**RE: Response Letter-Case Closure Review/Corrective Action Plan (CAP)
Laidlaw Transit-2900 Ladd Avenue, Livermore, California
Fuel Leak Case No. RO0000188, GeoTracker Global ID T0600100844
ACC Project Number: 3054-103.02**

Case Closure Review Response Letter/Corrective Action Plan (CAP)

2900 Ladd Avenue
Livermore, California

Subject: Case Closure File Review for Fuel Leak Case No. RO0000188 and GeoTracker Global ID T0600100844, Laidlaw Transit (Maintenance Yard), 2900 Ladd Avenue, Livermore, CA 94550

Title **Cross Section Overview Map
2900 Ladd Avenue
Livermore, California**

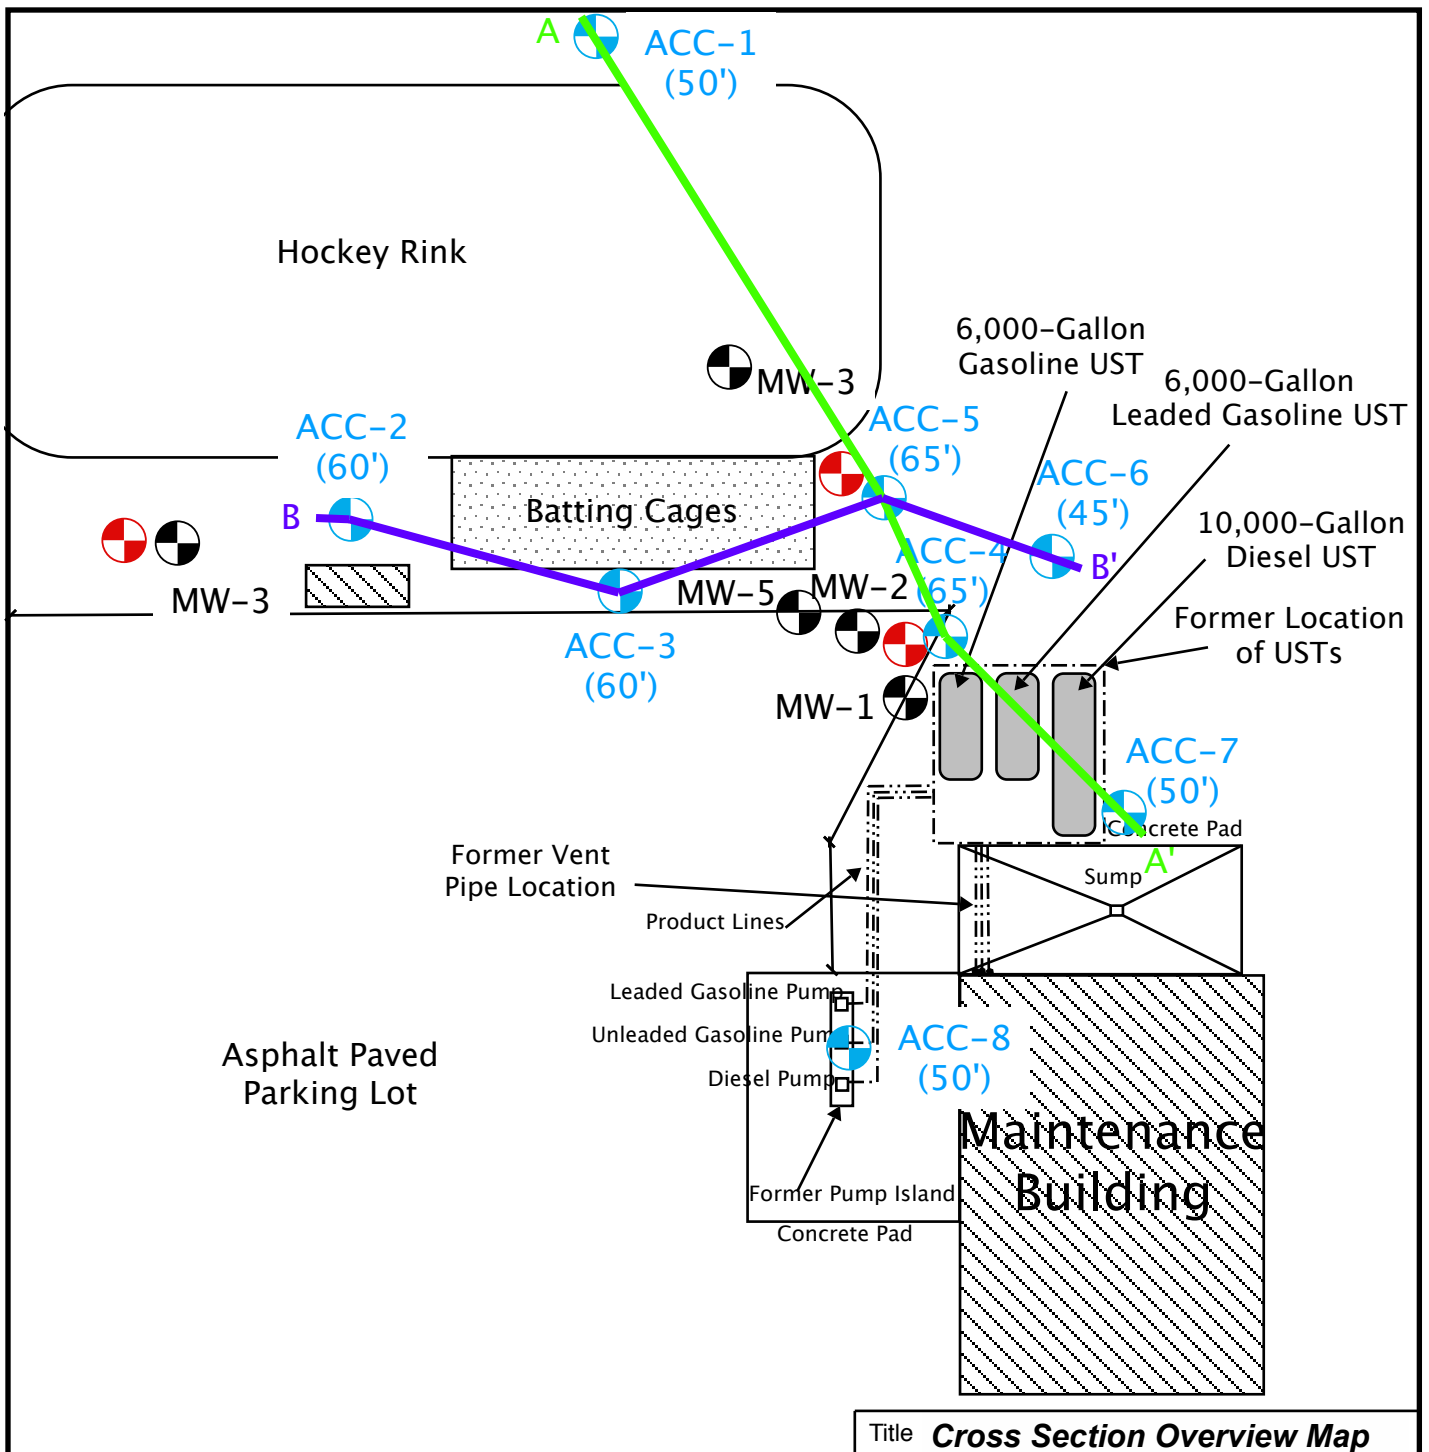
A municipal water supply well (CWS-17) is located approximately 550 feet southeast of the site. This well is in addition to water supply wells identified in the Closure Report. We understand that well CWS-17 is not active at this time but may be used in the future. Pumping of well CWS-17 has the potential to change hydraulic gradients in the area and cause contamination from the 2900 Ladd Avenue site to migrate towards the water supply well. Because well CWS-17 is a potential receptor for the site, the fuel leak case cannot be closed at this time. Preparation of a Draft Corrective Action Plan (CAP) is expected to be necessary. We recommend a meeting be scheduled with ACEH prior to preparation of a CAP. Please call me at (510) 567-6791 or send me an electronic mail message at jerry.wickham@acgov.org to arrange a meeting to review options.

The results of the sensitive receptor surveys conducted at sites in the area, indicated that there two active water supply wells/drinking water wells within 1/2 mile of the site. Both of these water supply wells/drinking water wells are located over 0.25 mile from the site. The closer water supply wells/drinking water well is located south from the site and the second water supply wells/drinking water well is located approximately 0.46 mile southwest from the site. Figure 5 illustrated the well locations.
